# Brocade Fabric OS v5.0.3 GA Release Notes v1.0

December 23, 2005

**Figure 14-1** Accessing Performance Graphs

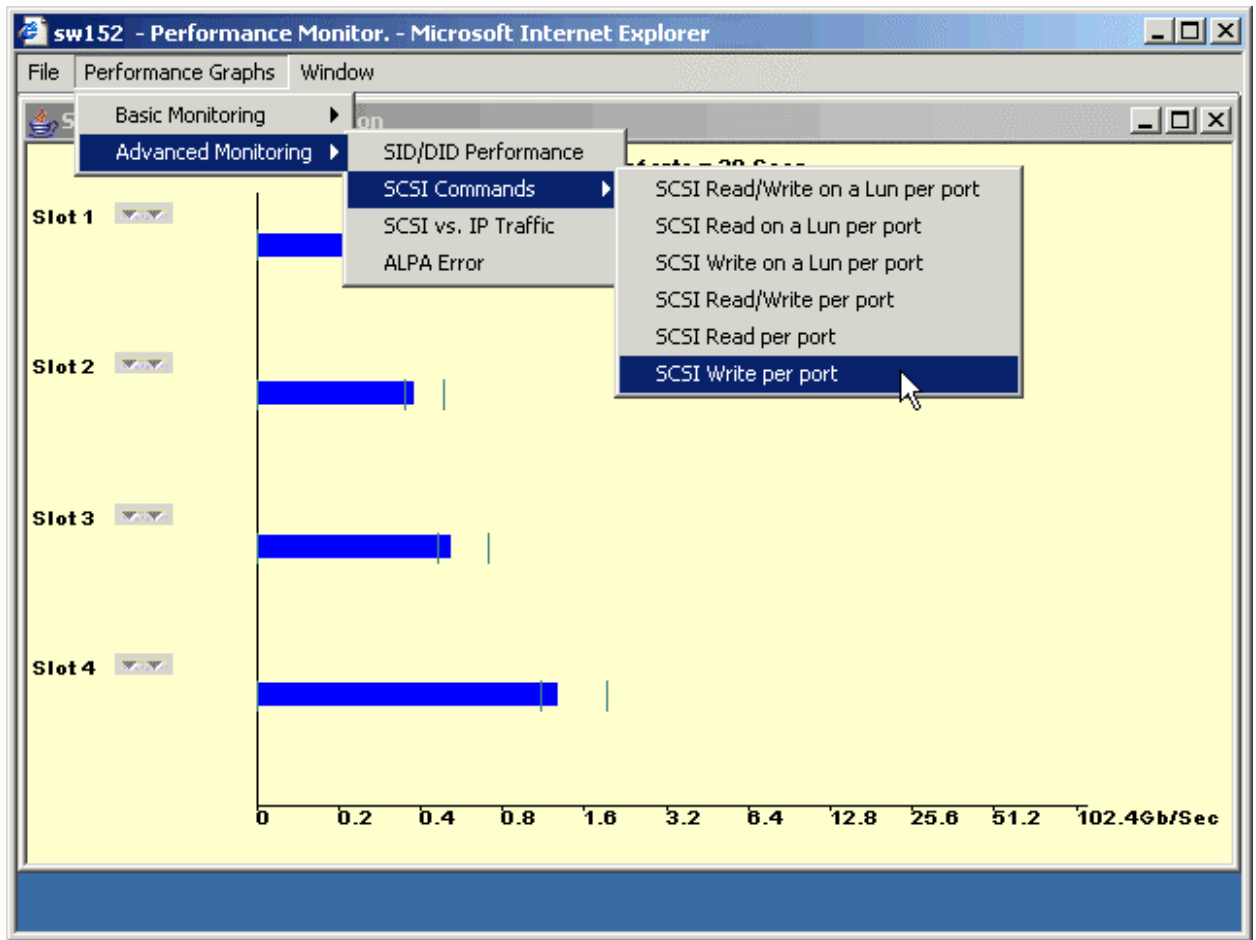
On page 14-3, replace Figure 14-1 with this one:

On page 14-3, add this paragraph after the first paragraph:

Port throughput utilization is represented by a horizontal bar for each selected port, which gets longer or shorter depending on the percent utilization for that port at the last poll time. Thin short vertical intersecting bars give a historical perspective by representing the highest and lowest values reached for each selected port since the graph was opened. A third bar between them represents the average of all values polled. (See Figure 14-1.)
